# SONY® Service Bulletin

NO: HIFI2-99-010

**SUBJECT:** DIM LIGHT/LOADING MOTOR MALFUNCTION

**MODEL (S):** DHC-MD7, MDS-M9

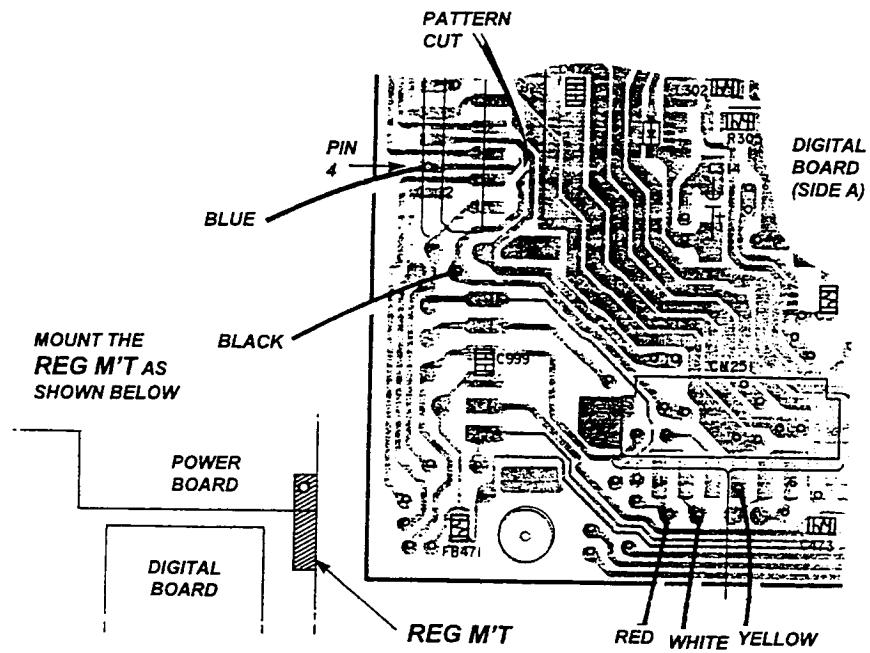
**SOLUTION:** Replace C113 and C114 on the POWER BOARD with improved versions.

Cut the foil pattern from CN223 (see diagram). Attach the wires from the REG M'T to the digital board as shown.

REF	DESCRIPTION	PART NUMBER
--	REG M'T KIT	A-4724-432-A
